Technical Service Bulletin

Cobra Motorcycle Mfg.

TSB0011 Early King Head Insert

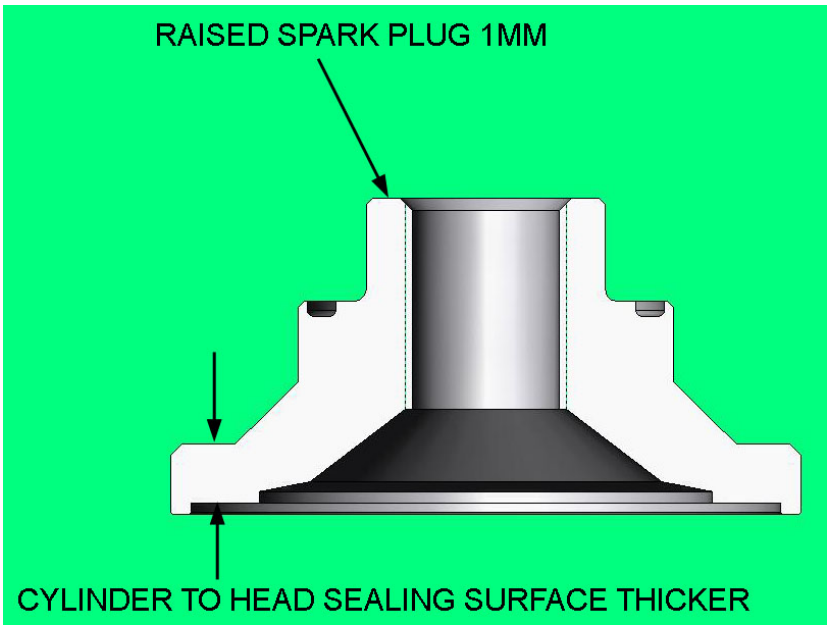
Some of the early 2011 Kings were produced with cylinder head insert that 1) allowed contact between the piston and the spark plug electrode, and 2) did not adequately seal combustion pressure from the coolant system.

To correct this, the inserts have been made 1) taller by 1mm to raise the spark plug, and 2) thicker to better seal combustion pressure.
